Service Bulletin

Bulletin No.: RS-84

Subject: BENDIX FUEL INJECTOR SYSTEM, MODIFICATION OF: RSA-7DA1 PARTS LIST 2524624-4
OR -5 TO PARTS LIST 2524624-6

Hook-up to Determine Fixture Accuracy and Detect Leakage
Figure 1

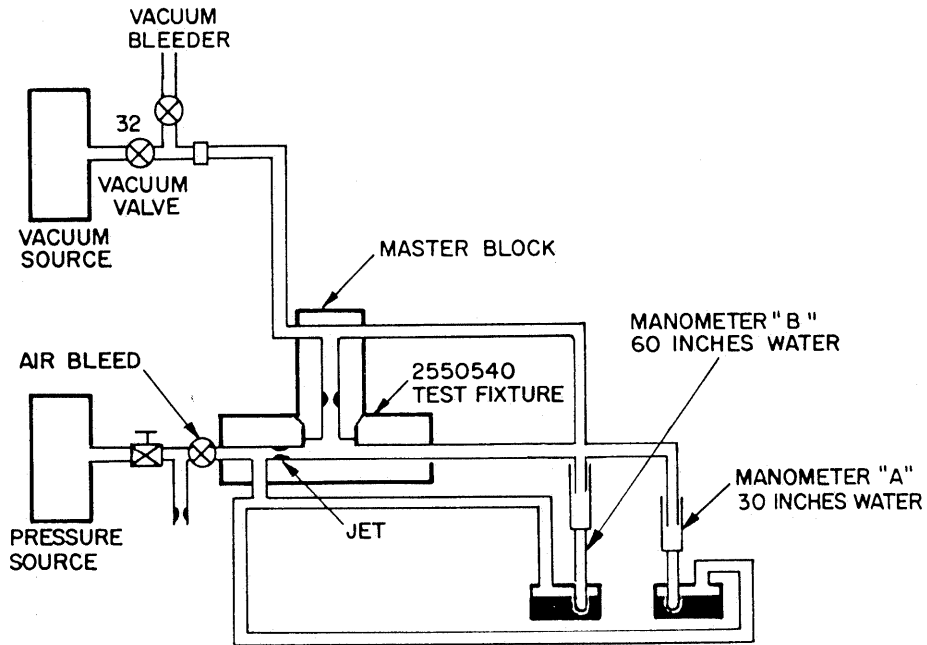
- (3) Install master block, with packing in place, on test fixture P/N 2550540.
- (4) Check test fixture for accuracy and leakage as follows:
 - (a) Close air bleed valve (Figure 1). Open the vacuum valve (32, figure 1) slightly until several inches of water show on manometer "B." Allow sufficient time for vacuum to purge air from the test fixture and master block. The reading on manometers "A" and "B" should be zero. If manometers "A" and "B" do not return to zero, a leak in the test circuit is indicated. Find and correct leak before proceeding.

- (b) Open air bleed valve fully. Adjust valve (32) until a reading of 15 inches water is shown on manometer "A." The 60 inch manometer "B" should indicate a reading equal to the value stamped on the master block (normally 18.4 to 18.5 inches water). If the value stamped on the master block cannot be obtained on manometer "B," an obstruction or leak is indicated in the test circuit.

AMC Test Hookup
Figure 2

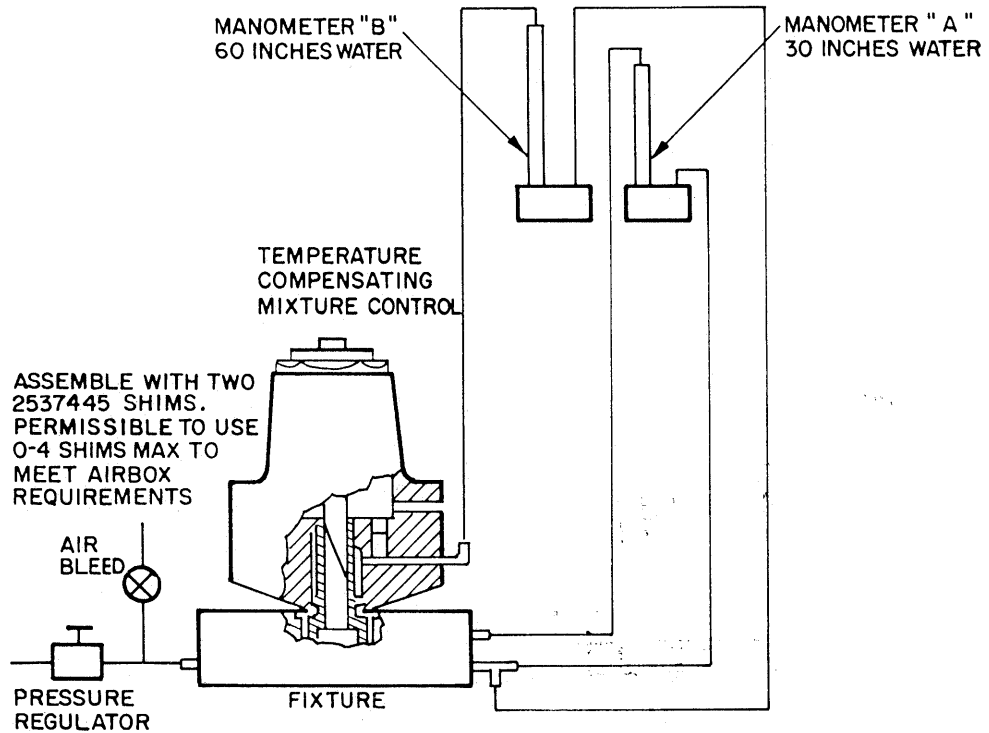
- (5) After checking the system for leakage and accuracy, remove the master block. Install temperature compensating control assembly on the test fixture per Figure 2. Make sure packing is in place. Do not overtighten holddown nuts or the packing will distort and cause an air leak.

NOTE: The venturi slots and channels into the suction chamber of the venturi are to be left open during calibration.
